**TO:** Daniel Sanchez, Field Operations Manager, OCD

**FROM:** Phillip Goetze, Engineering and Geological Services Bureau, OCD

**RE: INFORMATION ON DISPOSAL WELLS OPERATED BY SIANA OPERATING LLC (OGRID 168687)**

Completion Diagrams for Curry Federal No. 2 and APD Federal No. 1

Well: Curry Federal - 002  
 API: 3002524003  
 @ Srfce: T23S-R34E, Sec 22, 660FSL & 1830FWL  
 @ MTD: N. A.

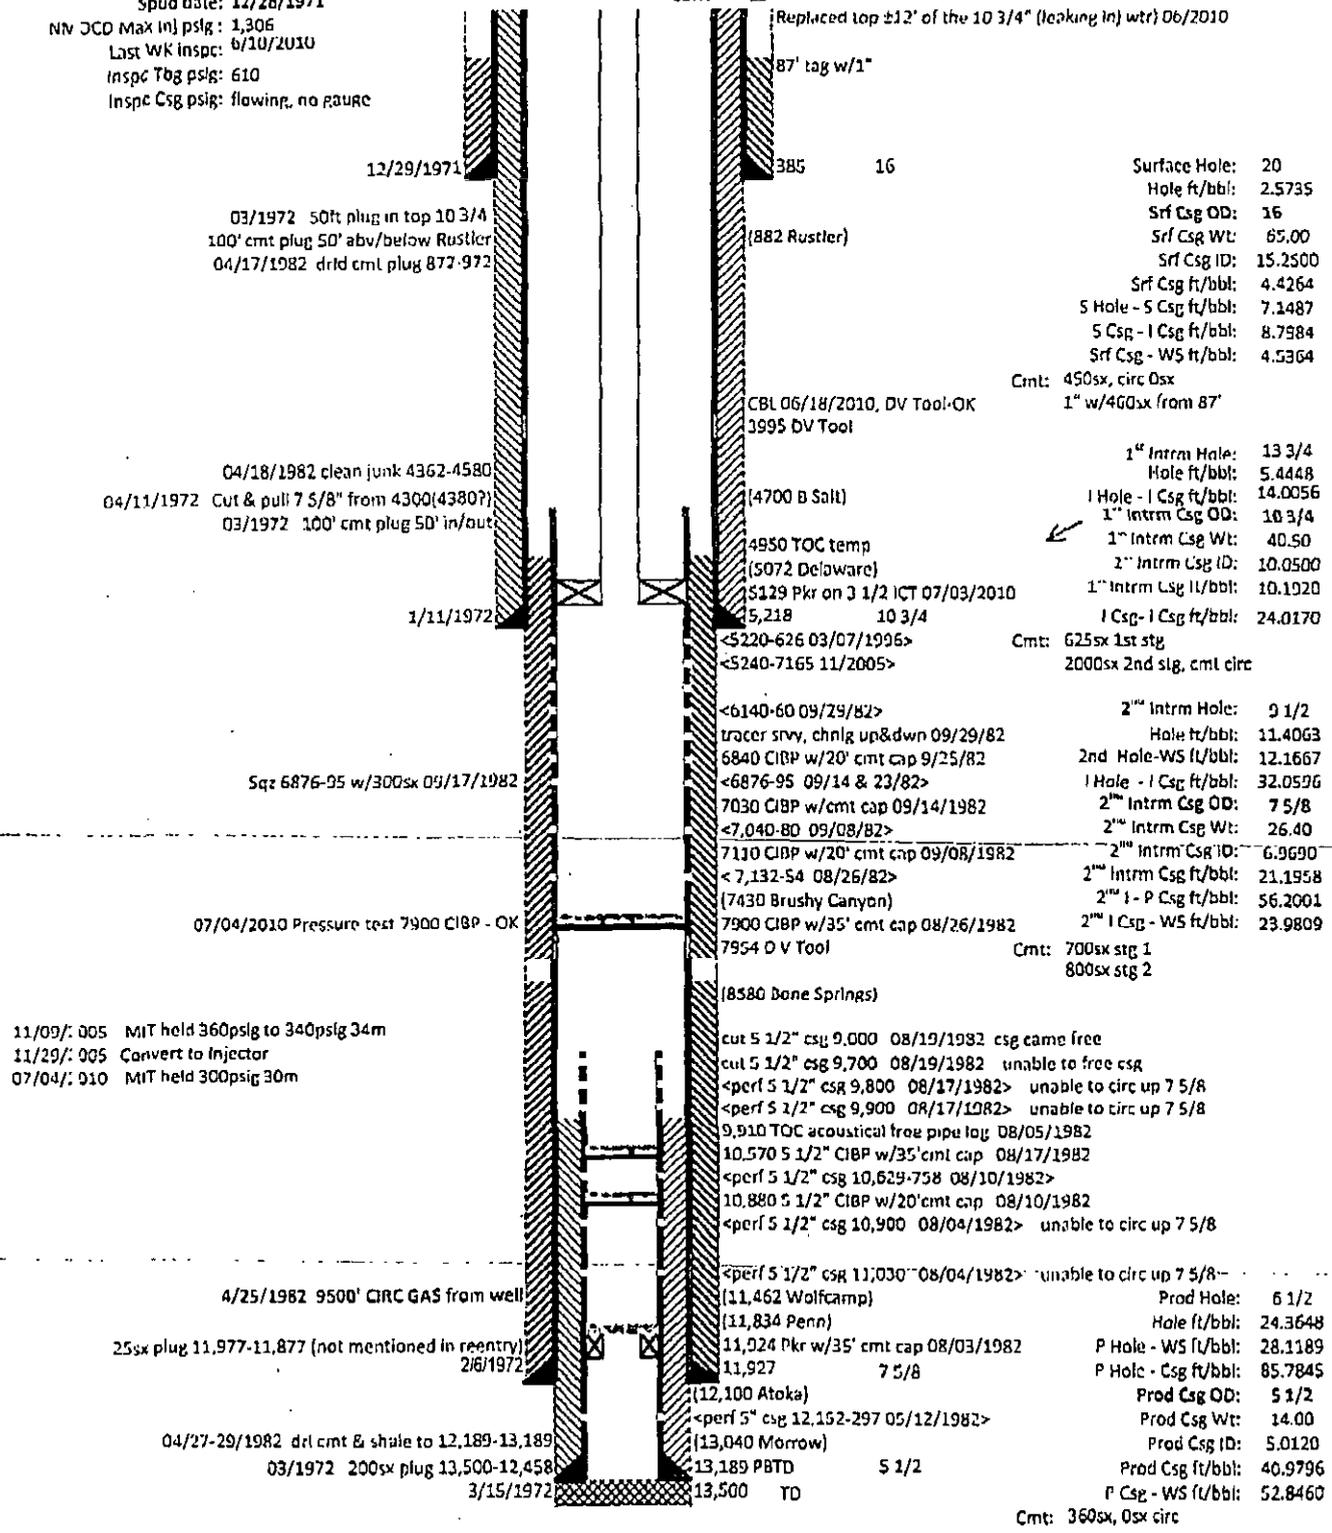
Completion Note: Well is currently injecting in interval not permitted under Order SWD-588. Operator filed subsequent report (state form C-103 dated November 29, 2005) that stated two CIBPs drilled out (6840 feet and 7110 feet). Additional perforations placed from 6220 feet to 7165 feet. No record of application to increase injection interval filed with OCD.
